Applicant: Brohm Mining Corp.

Date of Technical Revision Request: March 16, 1989

Nature of Request: Regarding off-load criteria and the variance for pH, NO2, and TDS.

TECHNICAL REVISION FACT SHEET

GENERALIZED CROSS SECTION OF BROHM LEACH PAD

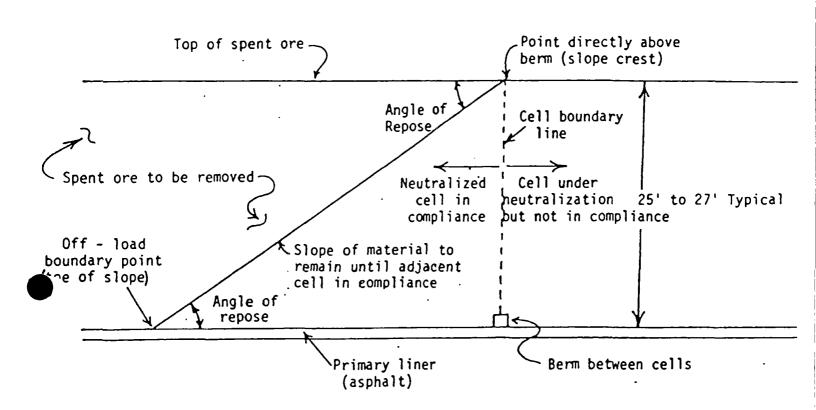
- 4. For each individual cell in compliance with approved neutralization standards, a cell shall only be off-loaded to a point on the primary liner as shown on the attached drawing and described as follows:
